GOVERNMENT OF THE DISTRICT OF COLUMBIA
DEPARTMENT OF TRANSPORTATION

MEMORANDUM

SUBJECT: **BZA Case No. 19061** – 1140 Florida Avenue, NE

Figure 1: On-Street PM Weekday Parking Type and Supply (Source: Symmetra Design)

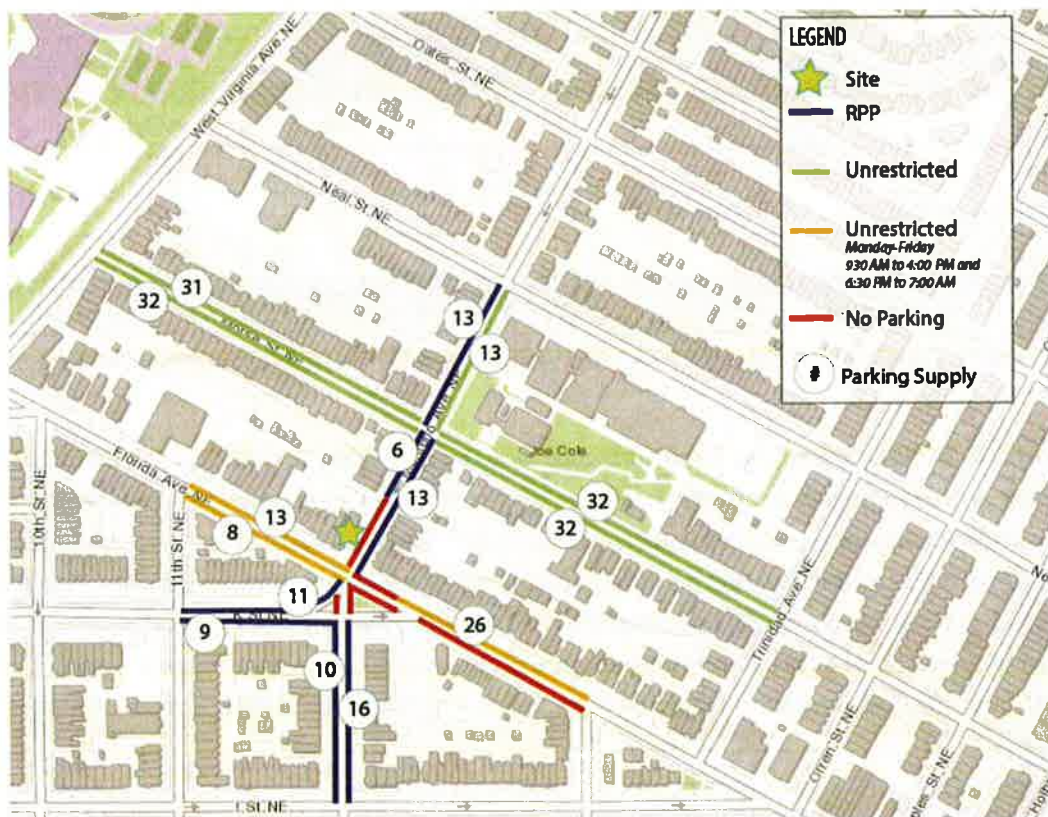
Zoning requires the provision of three parking spaces for the proposed seven-unit apartment building. The Applicant requests full parking relief. While this variance request does not meet DDOT's threshold for a vehicle parking occupancy study, a study was conducted by the Applicant, which was coordinated with DDOT. Parking occupancy data was collected on Thursday, August 27, 2015 at 8:00 pm. The Applicant and DDOT believed Thursdays at 8:00 pm, while District Public Schools are in session, are when parking demand is at its peak as a result of residential parking and parking by patrons of nearby H Street restaurants and bars. The analysis shows unused nearby on-street parking that would meet the proposed project's parking demand, with 55 spaces available during peak weekday demand in the study area (see Figures 1, 2, and 3). While both sides of the 1100 block of Montello Avenue are zoned as Residential Parking Permit (RPP), no parking is permitted immediately in front of the site on Montello Avenue due the presence of a fire hydrant and bus loading zone. Parking is permitted in front of the site on Florida Avenue during non-rush hours.
